TRANSMITTAL OF UNPUBLISHED PEER REVIEW REPORT

REPORT OF THE PEER REVIEW PANEL
ON THE
PROPOSED PROGRAM OF STUDIES OF THE
CALCITE AND OPALINE-SILICA DEPOSITS
IN THE YUCCA MOUNTAIN AREA
NEVADA

June 18, 1987

TABLE 1. FLOW PLAN FOR INVESTIGATIONS OF
THE CALCITE AND OPALINE-SILICA VEINS

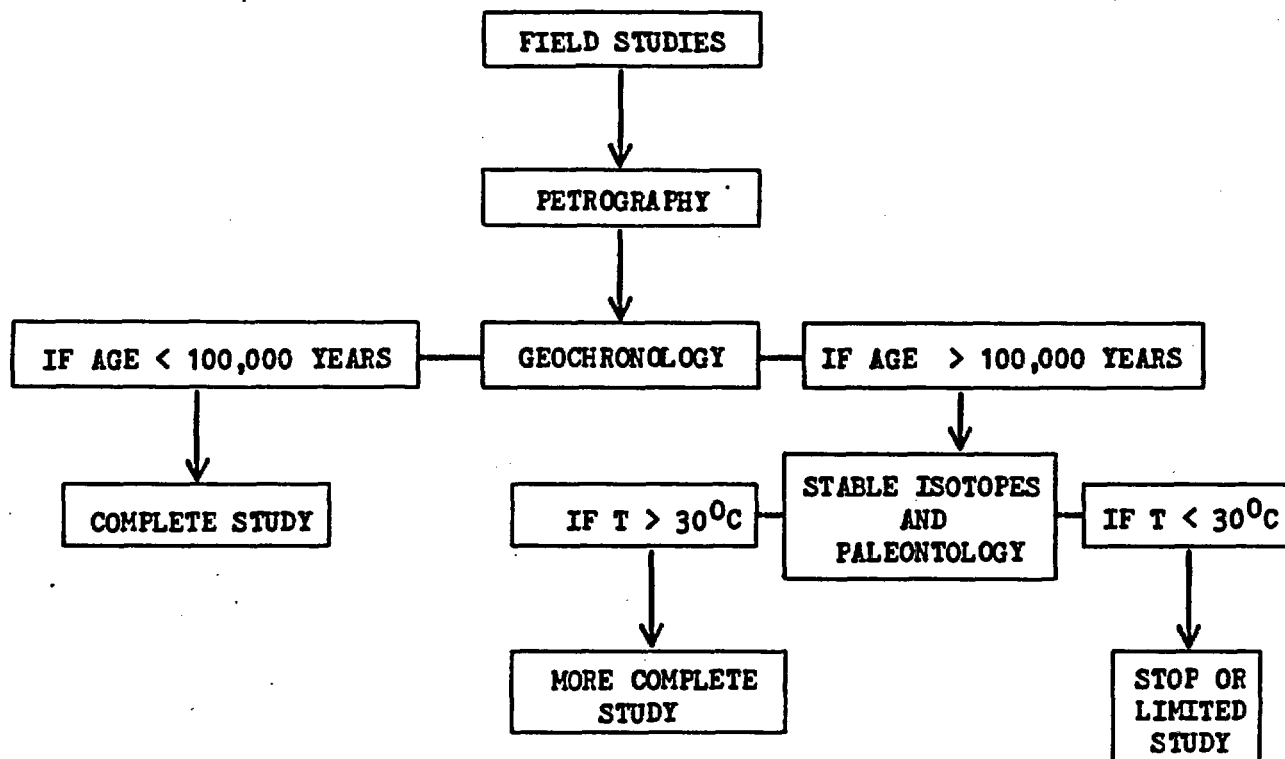
We recommend that field, petrographic, geochronological, stable isotope, and paleontological studies be undertaken at each site. Table 1 shows a plan for studies at each site. These studies are most important for: (1) helping to determine the age of the vein and breccia deposits associated with faulting; (2) placing constraints on time intervals between fault movements on a given fault assuming new veins are introduced at, or near, the time of faulting; (3) determining the temperature of waters responsible for the vein deposits; and (4) determining the origin of the veins and breccia. If the veins are young (i.e., less than 100,000 years old), a more complete study, including mineralogy; fluid inclusions; major, minor, and trace element; and tracer isotopes studies will be required. If the veins are old (i.e., greater than 100,000 years) and formed from cold waters, no further studies may be warranted. If the veins or breccias are old (i.e., greater than 100,000 years) and from hot waters, some limited mineralogical and geochemical studies may be warranted.
